Montana Department of Environmental Quality
Waste Management and Remediation Division
Waste and Underground Tank Management Bureau
Solid Waste Section

**Response to Public Comments Received for the
Proposed Land Application Site – T&D Construction & Excavation**

March 15, 2018

Figure 1.12: Land Application Site Boundaries and Setbacks

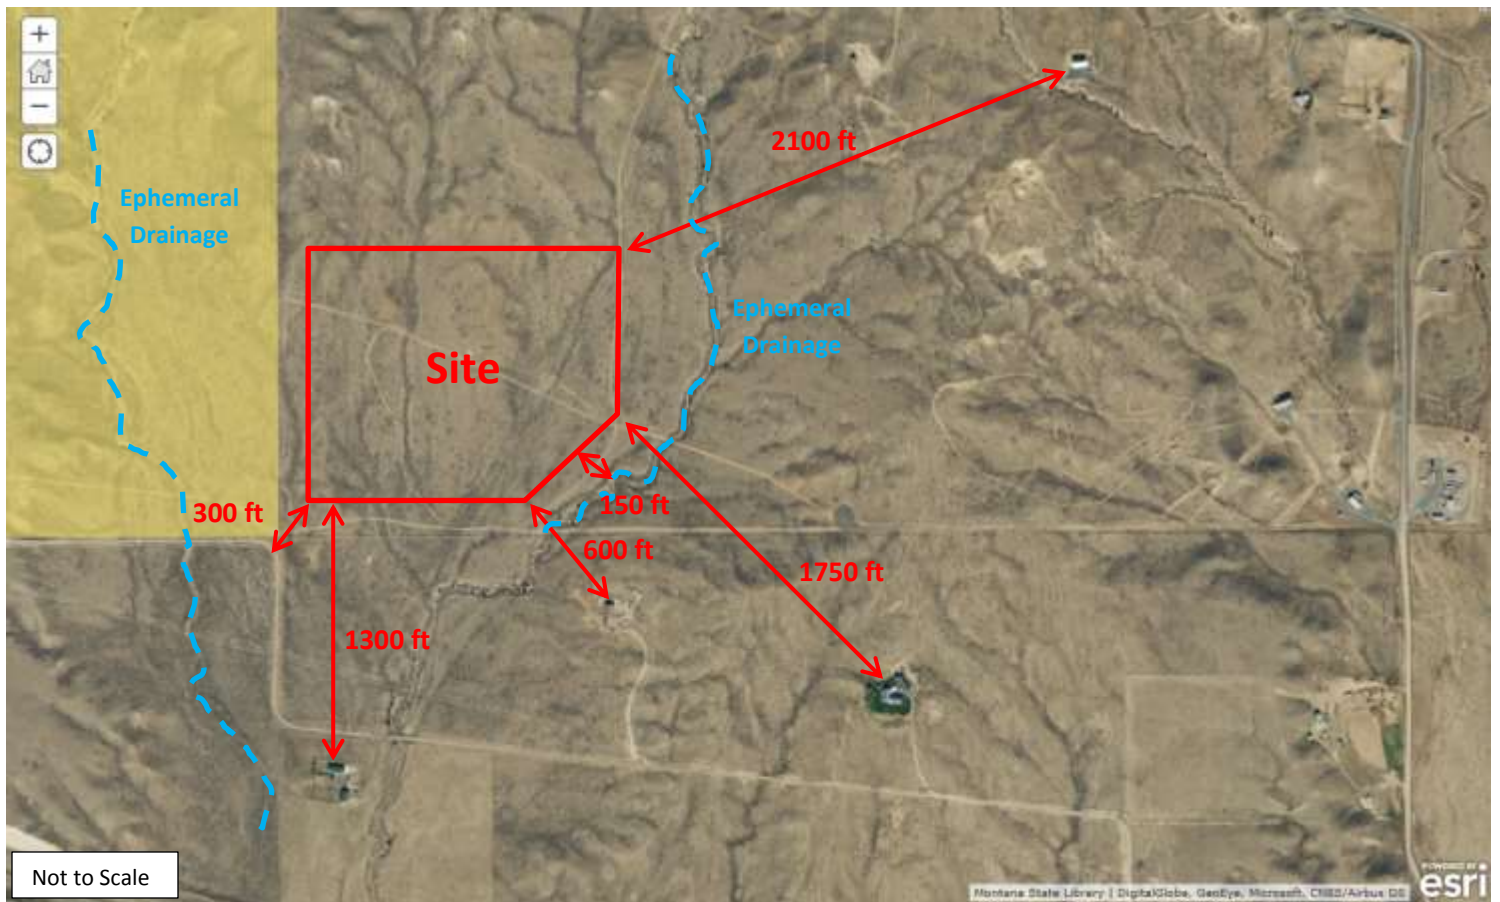
There may be an application for this kind of thing, but it needs to be further than 300 feet from a residential neighborhood.

Figure 1.12 is labeled as “Not to Scale”. How are distances determined if the map is not to scale?

The draft EA indicates that personal property located along the south west corner of the proposed site as shown in Figure 1.12 is 300 feet from a road or subdivision. It should be noted that the property line is closer than the 300 feet stated.

Errors on images in Figures 1.5 and 1.12 and text on page 2.

The regulations (ARM 17.50.809) prohibit the land application of wastes within 500 feet of any occupied or inhabitable building.

As noted in the draft EA and shown on Figure 1.12, the closest inhabitable building is approximately 600 feet from the land application site. The area proposed for land application meets the setback requirements noted above.

The label “Not to Scale” is used in DEQ’s draft EA to avoid errors that may arise as a result of the editing and printing process or web publication. DEQ utilizes the ESRI ArcGIS program to map and measure distances to ensure the proposed land application areas comply with the setback requirements in the regulations.

As shown in Figure 1.12, the 300-foot distance is to the road that runs to the south of the proposed land application site. This location was measured and labeled due to it being the closest proximity the road comes to the borders of the land application site. The regulations require a setback of 100 feet from any state, federal, county, or city-maintained highway or road. The setback from a habitable building is 500 feet and there are currently none that have been constructed within that distance. The proposed land application site meets the requirements of these regulations.

As stated in Response 3, the regulations prohibit land application within 150 feet of any state surface water, including ephemeral or intermittent drainages and wetlands. The recognized drainages for this site include the two as labeled in Figure 1.12 to the east and west of the site. The areas approved for land application are outside the 150-foot setback.

- Figure 1.5 has been revised
- Figure 1.12 has been revised
- Text on page 2 has been changed from Whitehall Creek to Whitetail Deer Creek
